VULCAN PHASE 3.3

535 8th Ave North  
Seattle, WA 98109

### **PROJECT #: #3039270-LU**

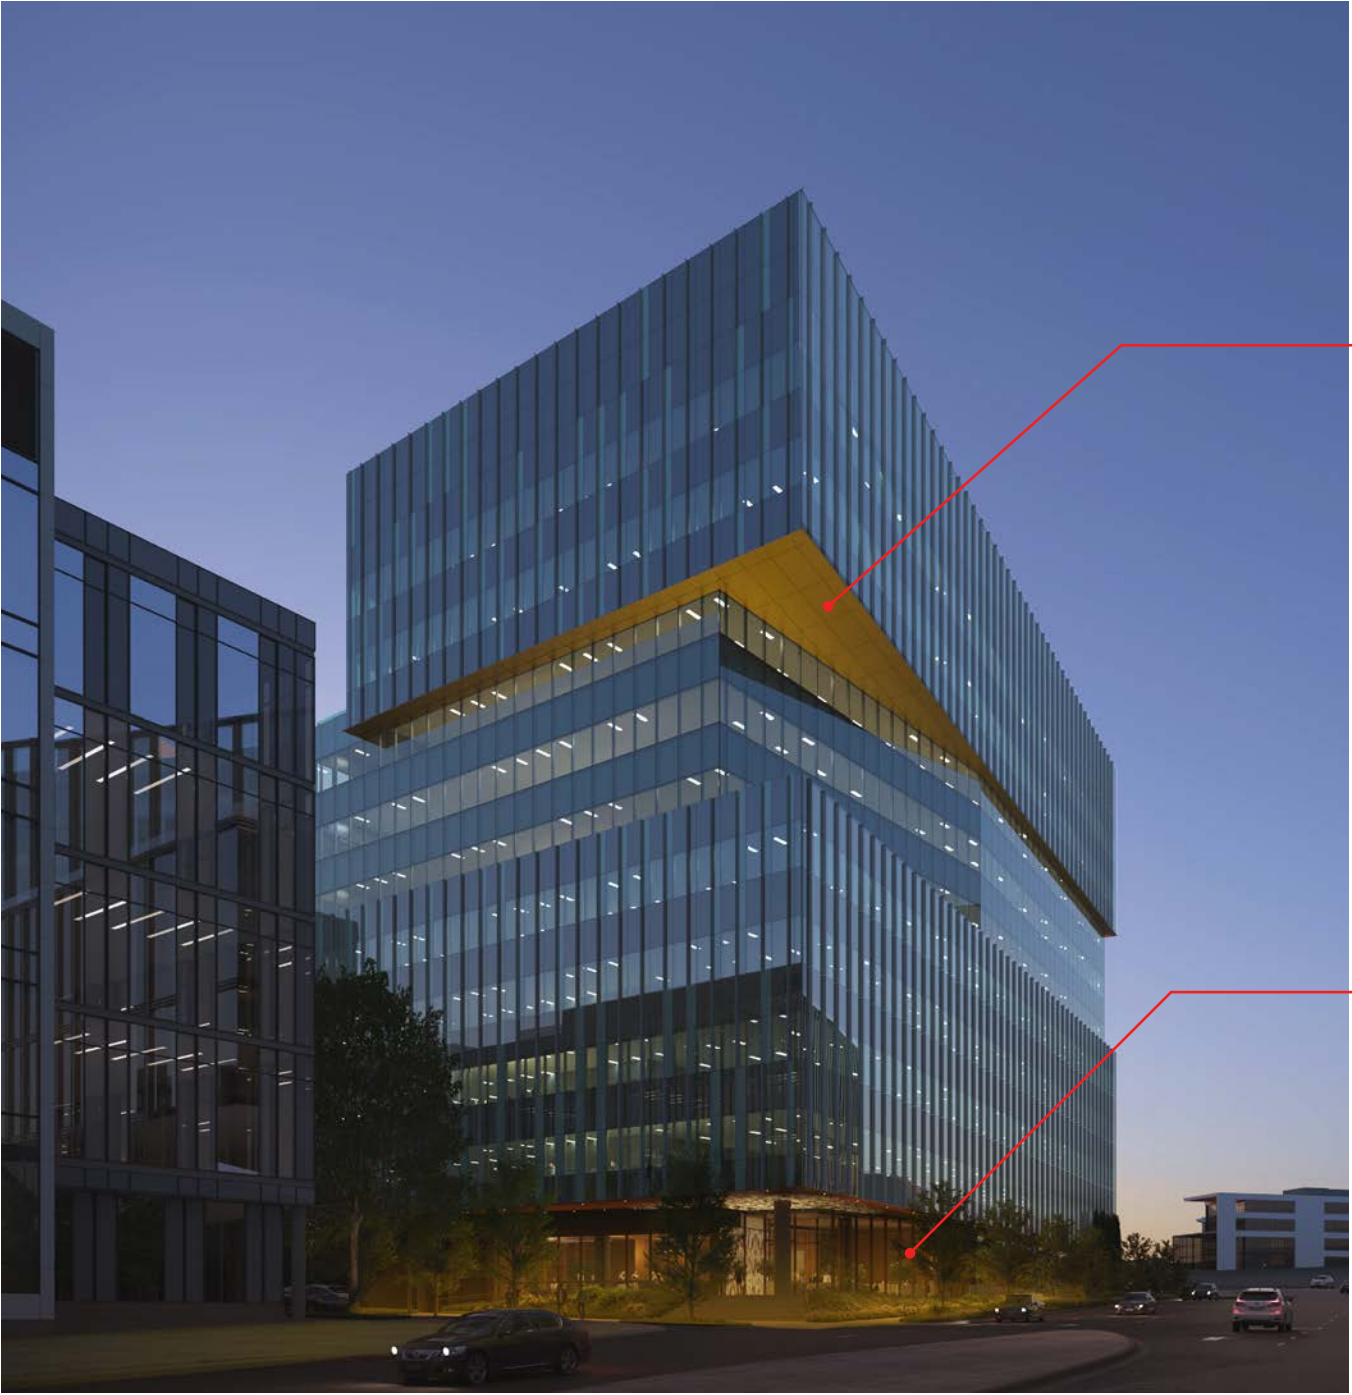
**REC1 Guidance / 3.b**  
The Board supported the overall lighting plan and approach with its ambient pedestrian lighting at the ground level and the backlighting effect proposed at the large building overhang soffits to reinforce the overall architectural massing concept at night. DC4-D

**REC2 Design Response:**  
The supported lighting design has been further developed to increase the scope of the backlit soffits at the ground floor, and to revise the technical means of lighting the upper level soffits to better illuminate them at the urban scale.

Façade Modulation (Supported at EDG)

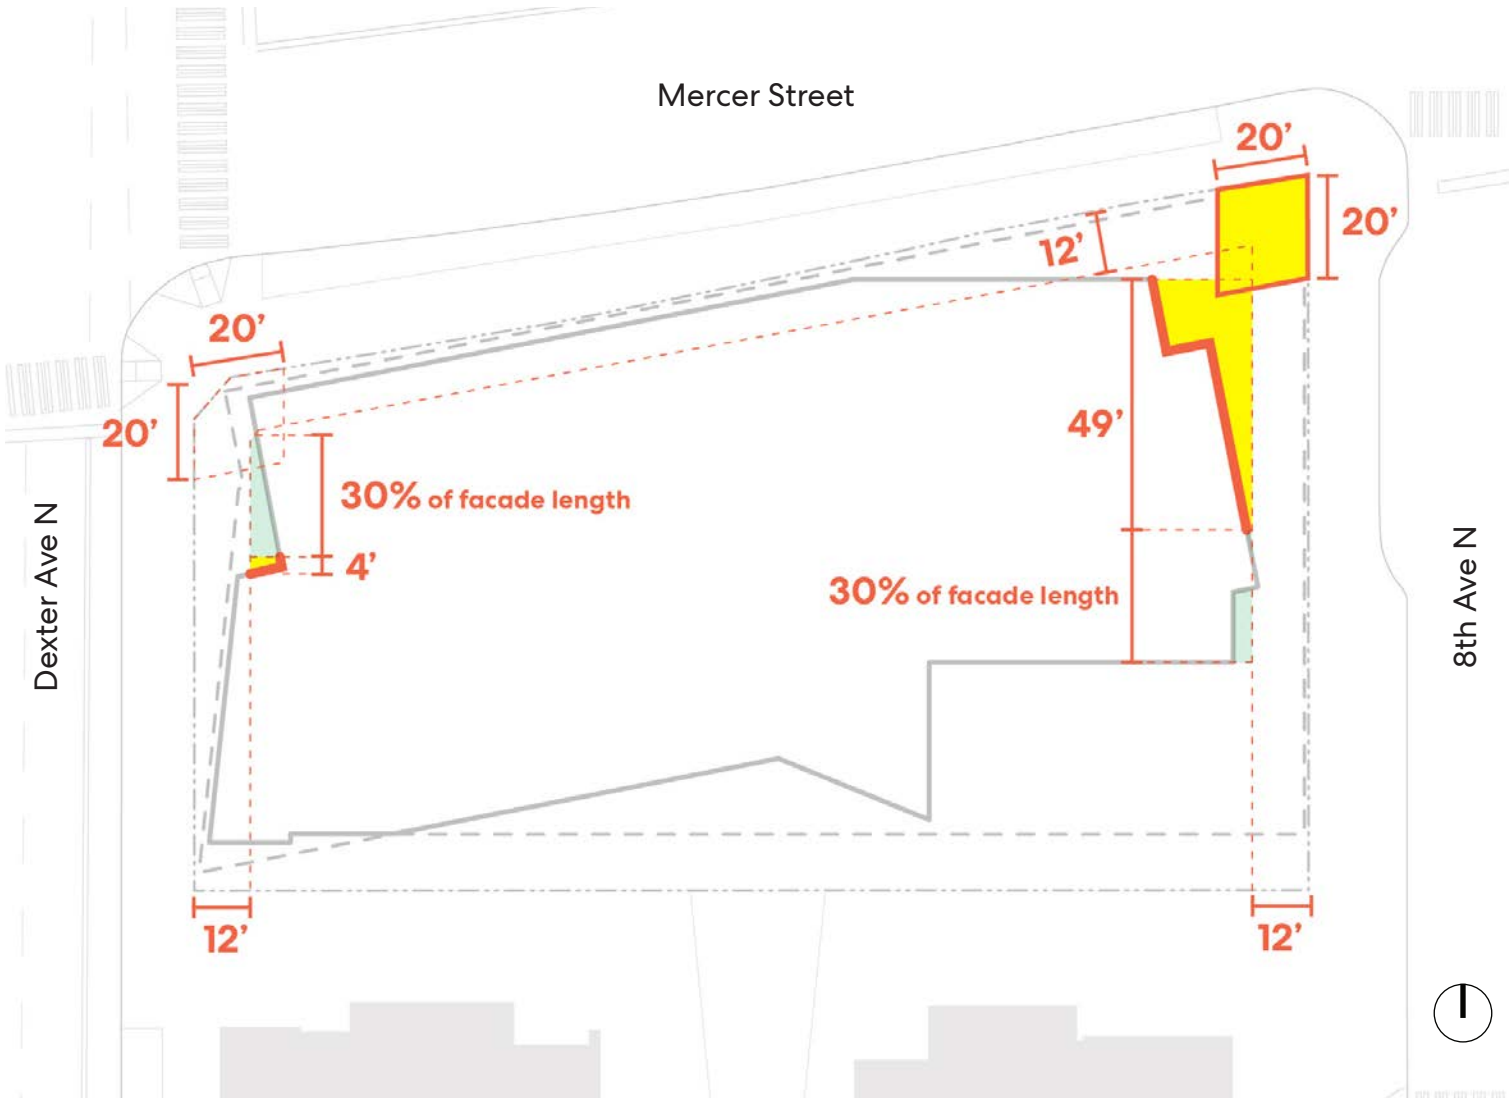
SMC 23.48.245.D  
For all structures with non-residential uses exceeding 85 feet in height, facade modulation is required for the street-facing portions of a structure located within 15 feet of a street lot line and exceeding the podium height. Maximum length of unmodulated facade for stories up to 145 feet is 150 feet. Maximum length of unmodulated facade for above 145 feet is 120 feet. If a portion of a facade that is within 15 feet of the street lot line is the maximum length permitted for an unmodulated facade, the length of the facade may be increased only if additional portions of the facade are set back a minimum of 15 feet from the street lot line for a minimum distance of 40 feet.

Request to provide two portions of the north façade along Mercer Street that are 40' long beyond the maximum length of 150 feet for below 145 feet, and one portion that is 40 feet long beyond the maximum length of 120 feet for above 145 feet. The east portion of Levels 6-8 to be more than 15' away from property line. The west portion of Levels 6-8 to be 2' 6" to 4' 2" away from property line. Volumetrically, the amount of additional setback provided beyond the code requirement is more than the departure amount.

Street-Level Setbacks (Supported at EDG)

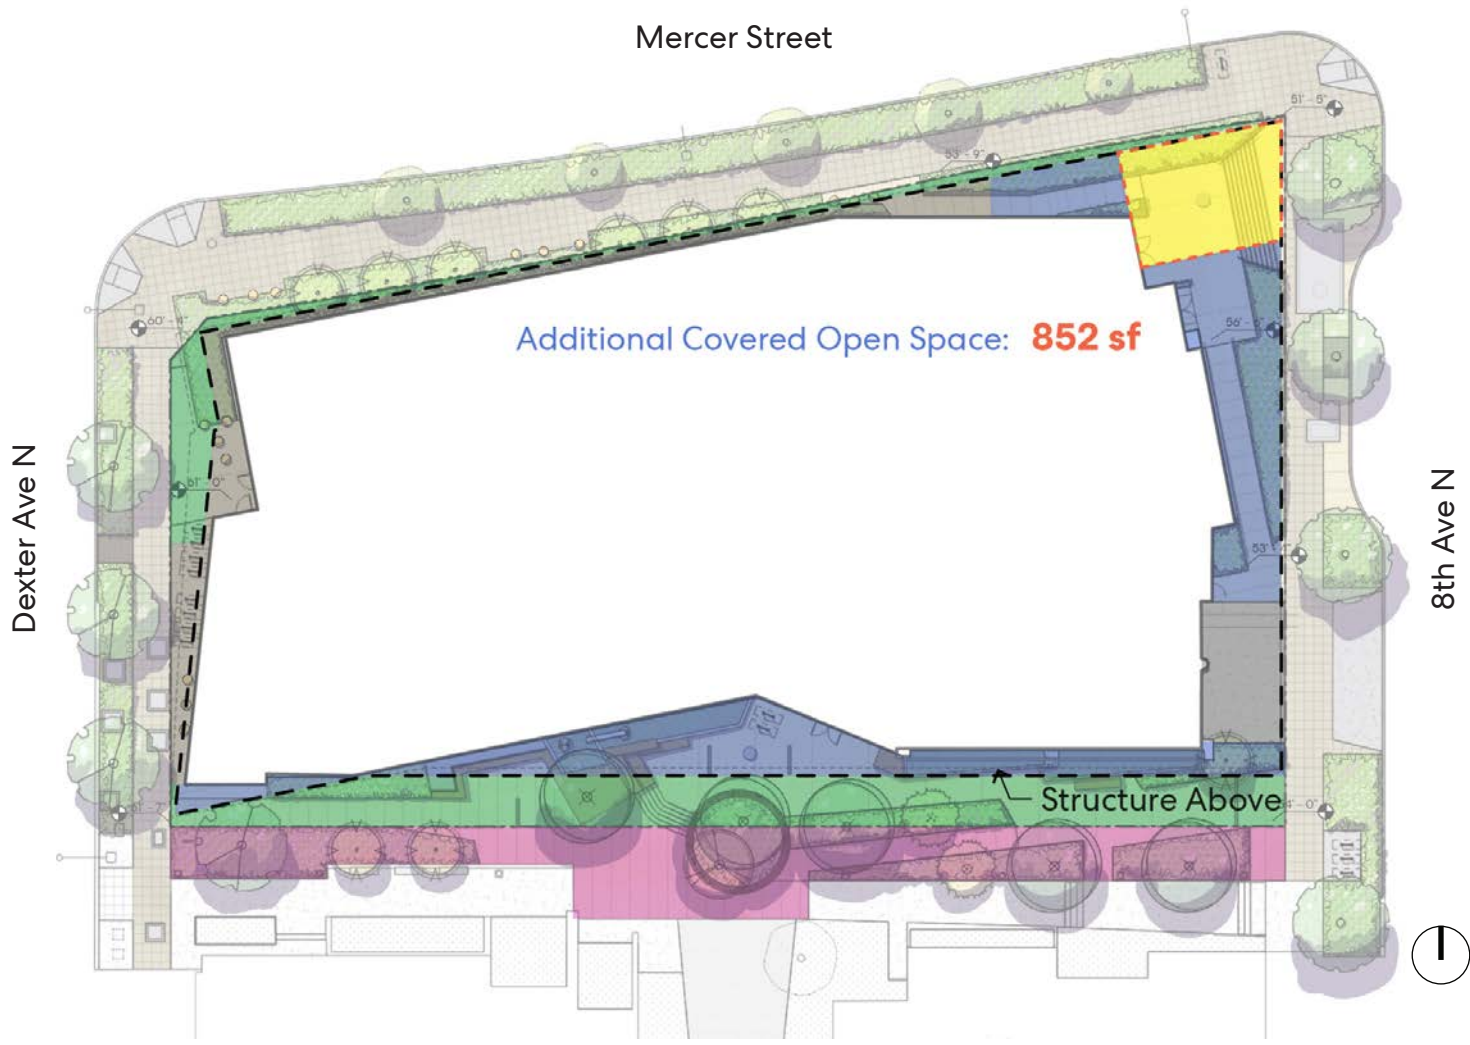
**Code:**  
SMC 23.48.240.B.1.b  
The street-facing facade of a structure may be set back up to 12 feet from the street lot line. Additional setbacks are permitted for up to 30 percent of the length of portions of the street-facing facade that are set back from the street lot line, provided that the additional setback is located 20 feet or more from any street corner.

**Proposed:**  
Request to locate the northeast corner of the street-facing facade further than 20 feet from street corner. Request to have 49' of east facade and 4' of west facade beyond the allowed 30% to be further than 12' from street lot line.

Parking Space (Supported at REC 1)

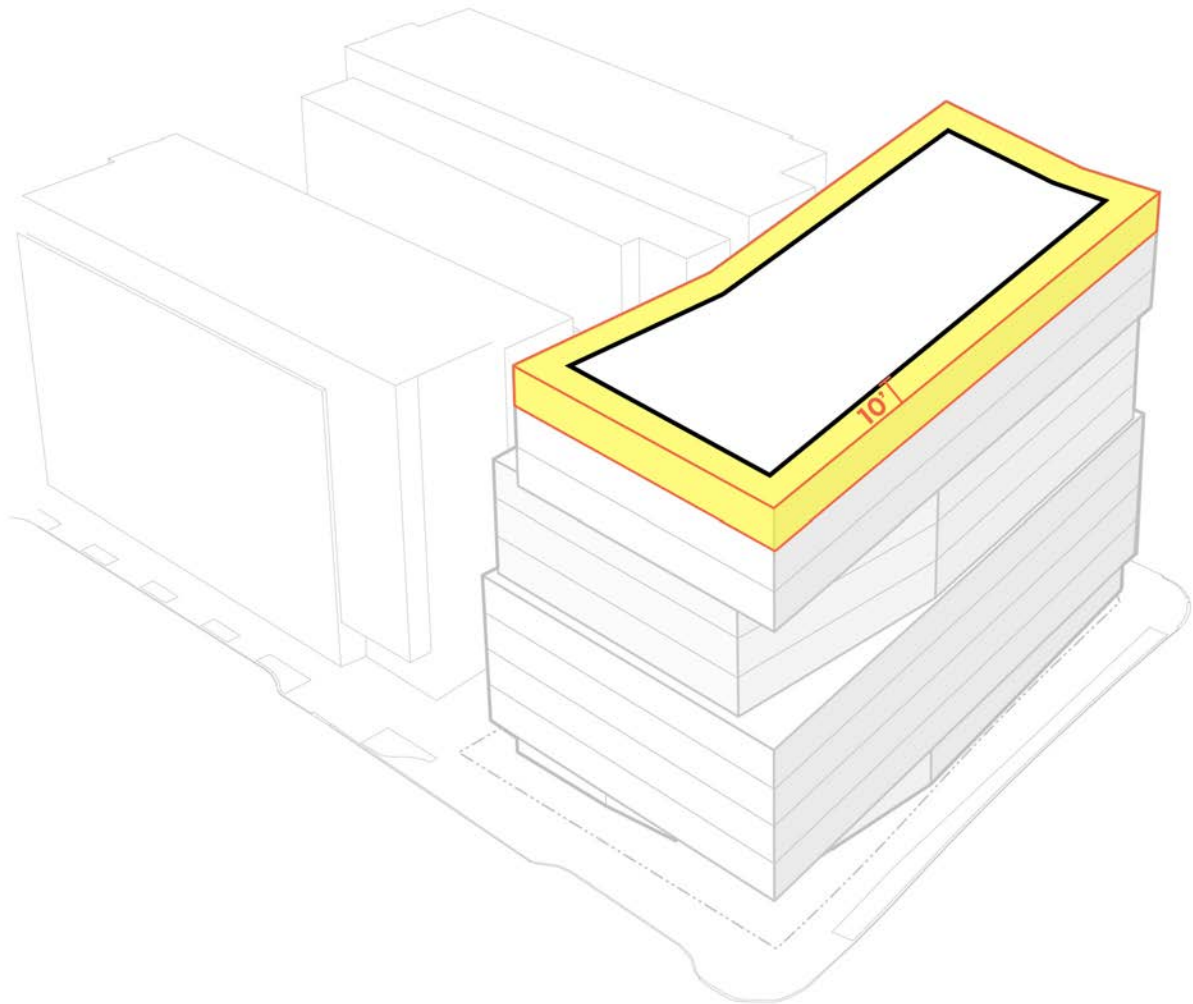
**Code:**  
SMC 23.54.030.B.2.c  
When 20 or more parking spaces are provided, a minimum of 35 percent of the parking spaces shall be striped for small vehicles.  
A maximum of 65 percent of the parking spaces may be striped for small vehicles.  
A minimum of 35 percent of the spaces shall be striped for large vehicles.

**Proposed:**  
Request to provide a minimum of 25 percent of parking spaces for large vehicles, and a maximum of 75 percent for small vehicles.

**Rooftop Features (Supported at REC 1)**

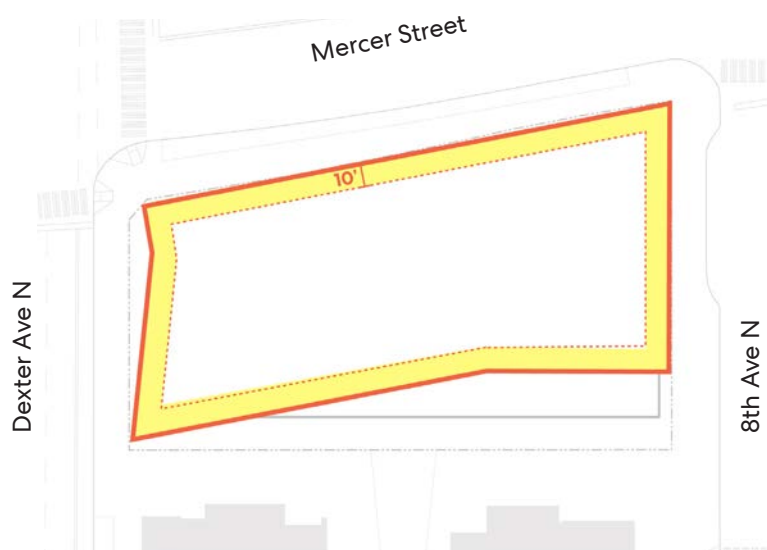
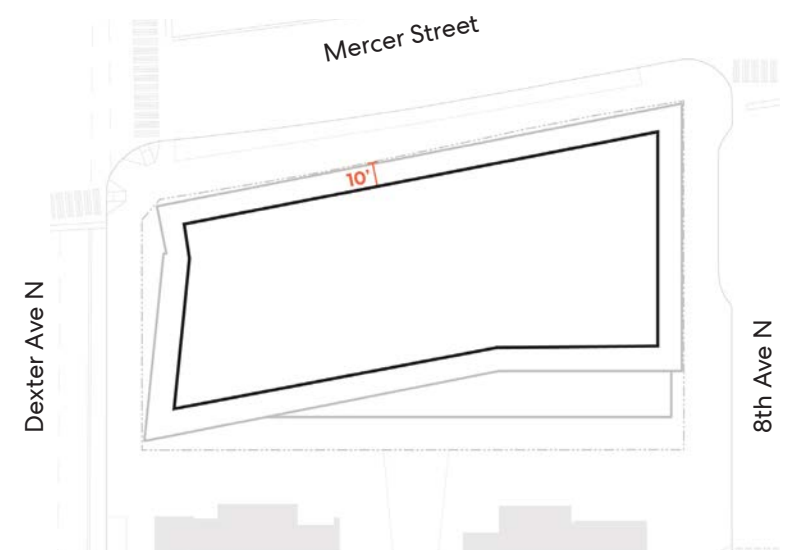
At the applicant's option, the combined total coverage of all features listed in subsections 23.48.025.C.4 and 23.48.025.C.5 may be increased to 65 percent of the roof area, provided that all of the following are satisfied:

- a. All mechanical equipment is screened or enclosed; and
- b. No rooftop features are located closer than 10 feet to the roof edge.

Request to provide up to 100% rooftop feature coverage and locate rooftop features closer than 10 feet to the roof edge. All mechanical equipment is screened.

West Elevation - Dexter Ave N (Class II Pedestrian Street)

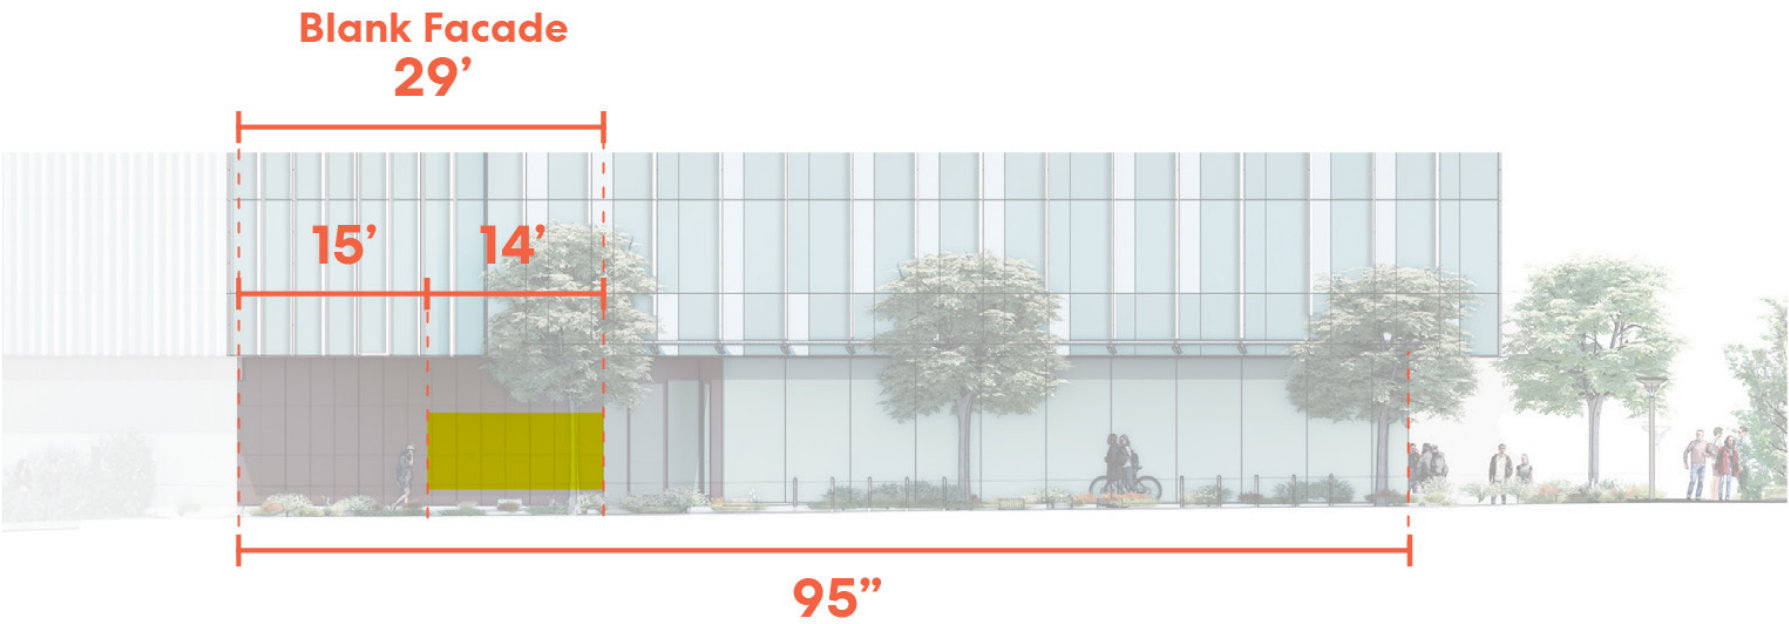
SMC 23.48.040.B.2.a.1  
Blank facades are limited to segments 15 feet wide. Blank facade width may be increased to 30 feet if the Director determines as a Type I decision that the facade is enhanced by architectural detailing, artwork, landscaping, or other similar features that have visual interest.

Request to provide a segment of 30' 0" of blank facade along Dexter Ave N (Class II Pedestrian Street).
